Charlotte-Mecklenburg Planning Department

SUBJECT: Administrative Approval for Petition No. 2008-086 Citiline Resortline Properties

GATEWAY WEST

REZONING PETITION
2008-086

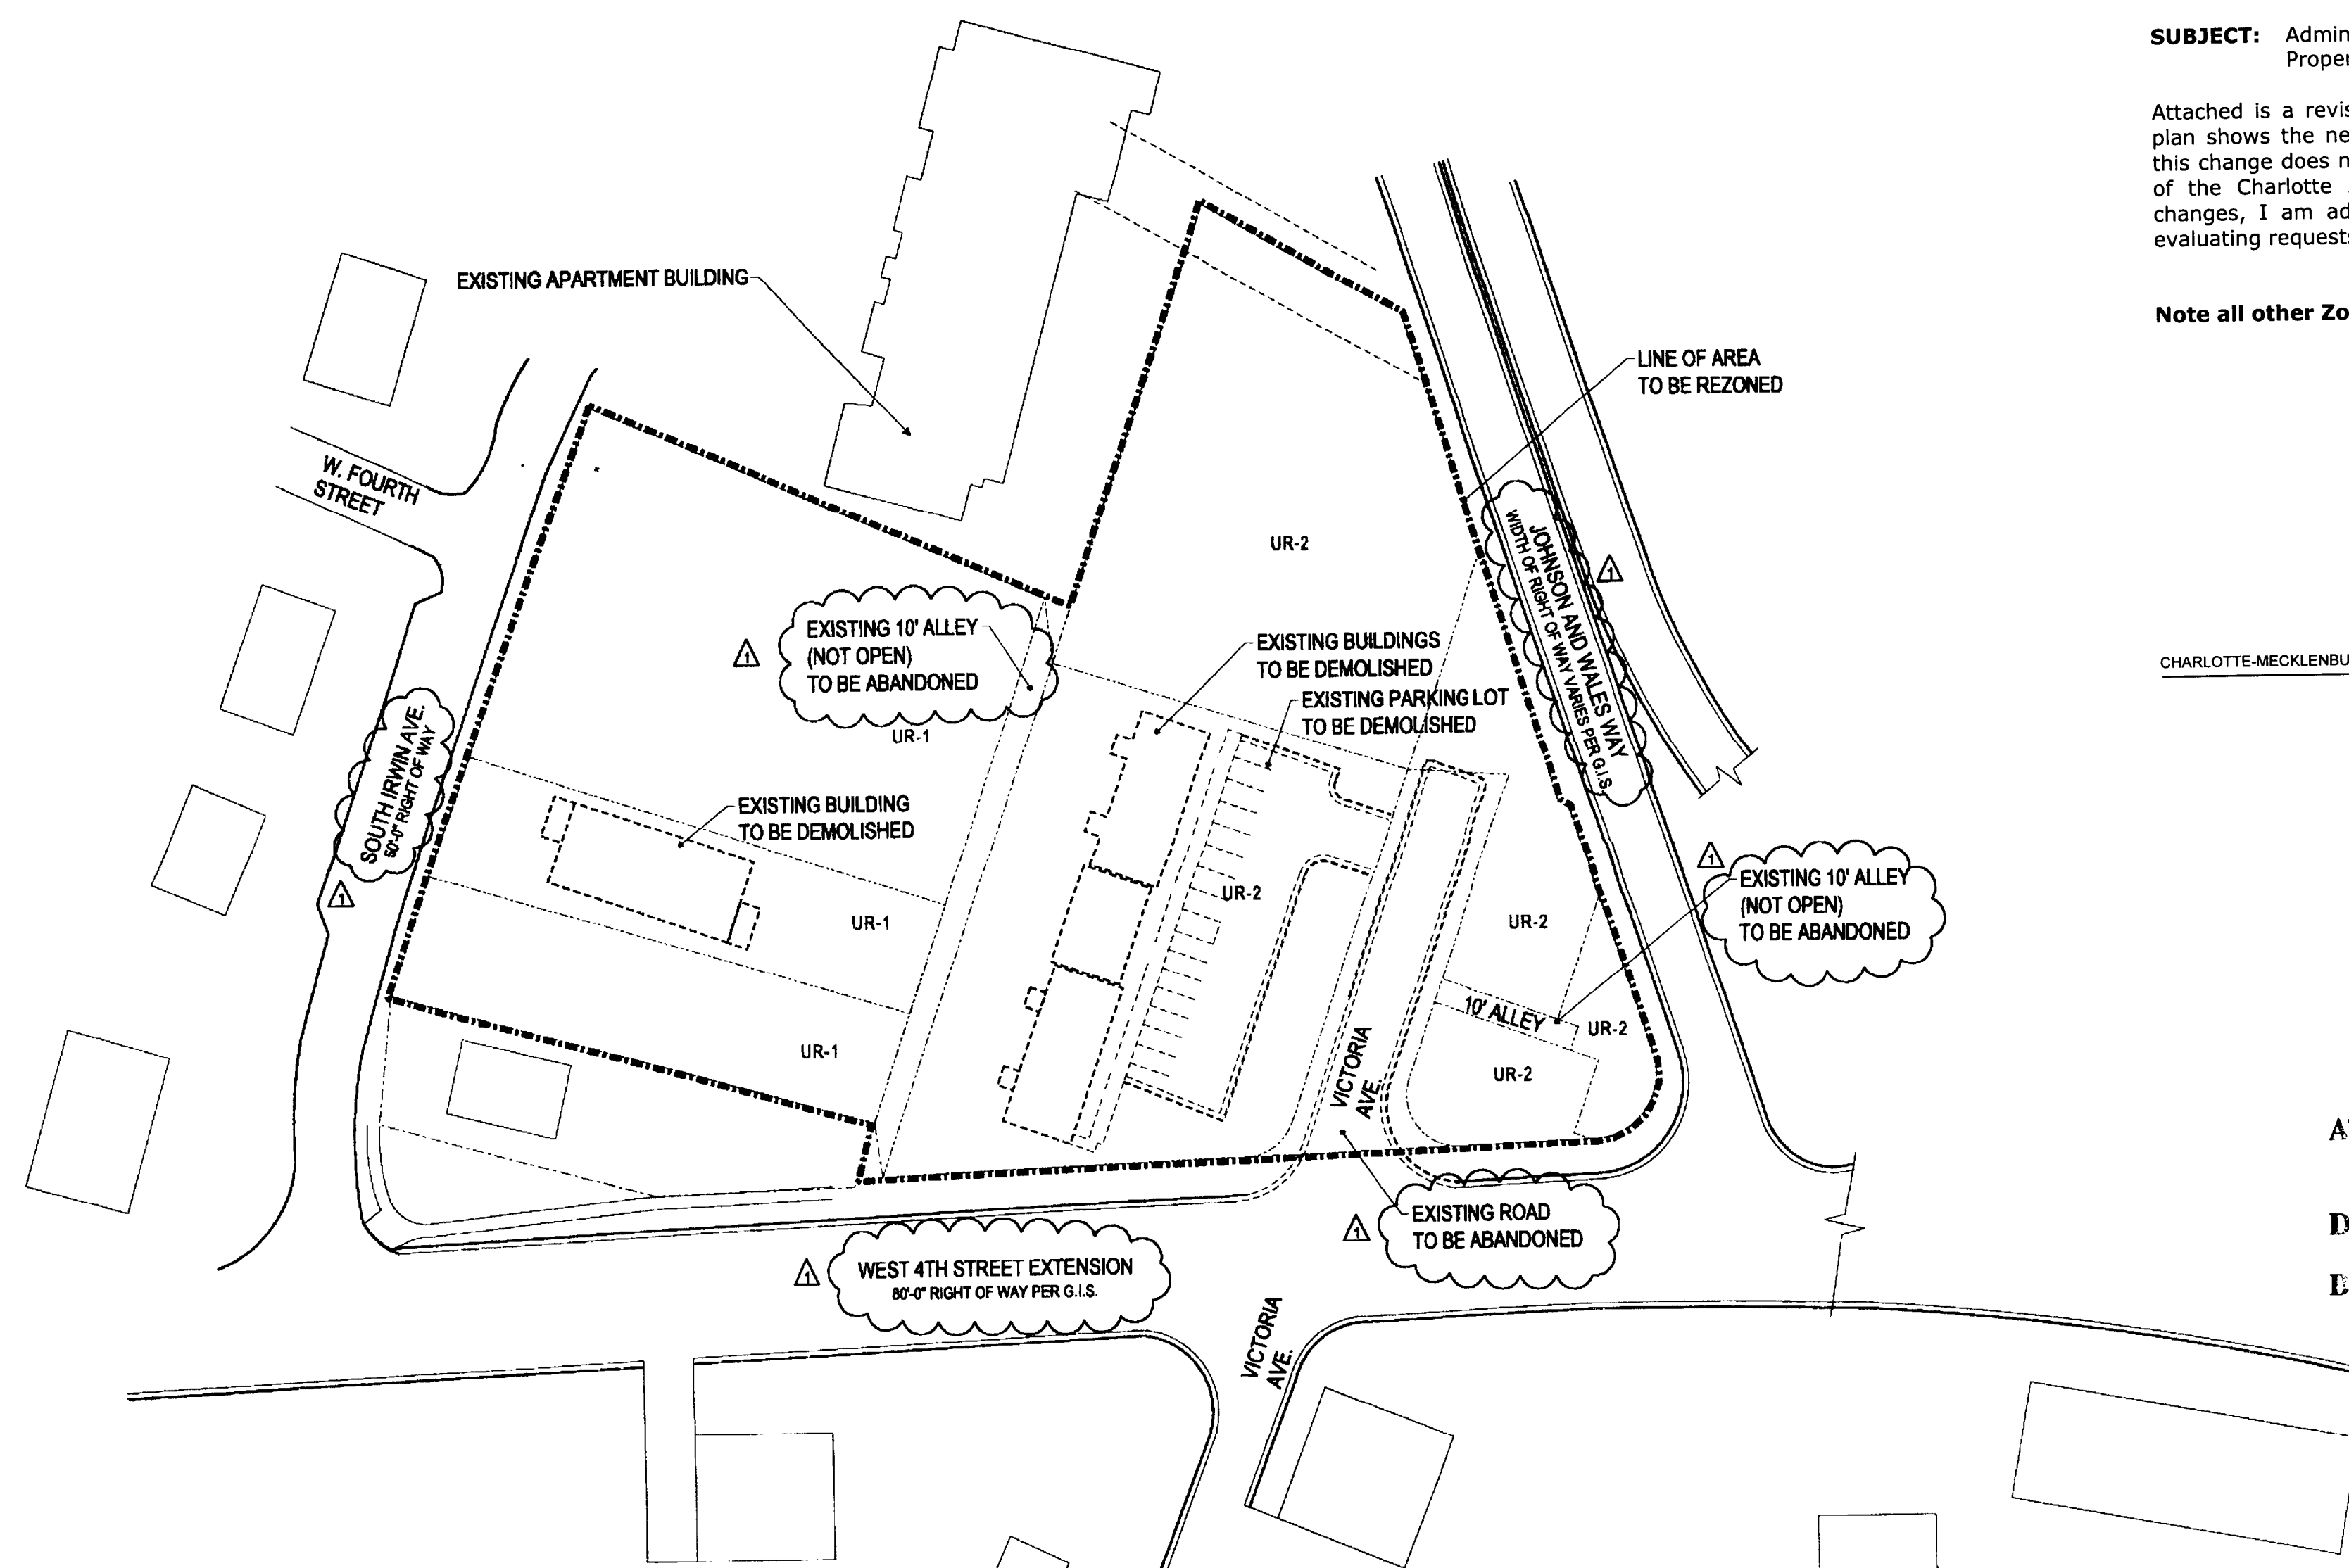
Attached is a revised site plan for the above referenced rezoning petition. The site plan shows the new site layout and changes to the required pedestrian path. Since this change does not alter the intent of the development and meets the requirements of the Charlotte Zoning Ordinance Section 6.207 Alterations to Approval, minor changes, I am administratively approving this plan. Please use these plans when evaluating requests for building permits and certificates of occupancy.
